MAS002980 (MSC 22-08)

Campaign 487 FROM Maserati TSO TO Maserati Network

# Service Campaign 487 MC20 - Water infiltration through door wiring area

DATE: April 1, 2022

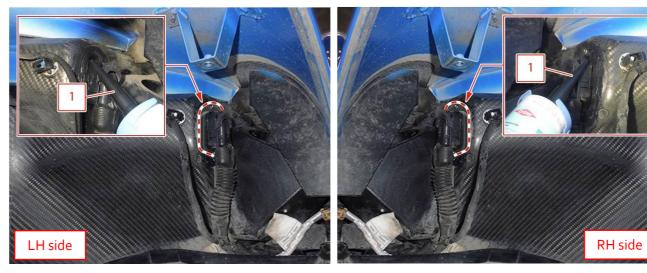
This possible infiltration is caused by a poor coupling between the aluminium bracket of the door connector and the carbon fiber of the monocoque body, which could be uneven in the coupling area.

This sealing is necessary to minimize the possibility of water pooling in a hollow section of the monocoque, which could also cause a sloshing noise while driving.

9. Proceed by sealing the highlighted areas

10. The sealants listed below are approved by the factory and must be purchased locally.

11. Apply the sealant (1) around the entire perimeter of the DTB (Door to Body) connector bracket:
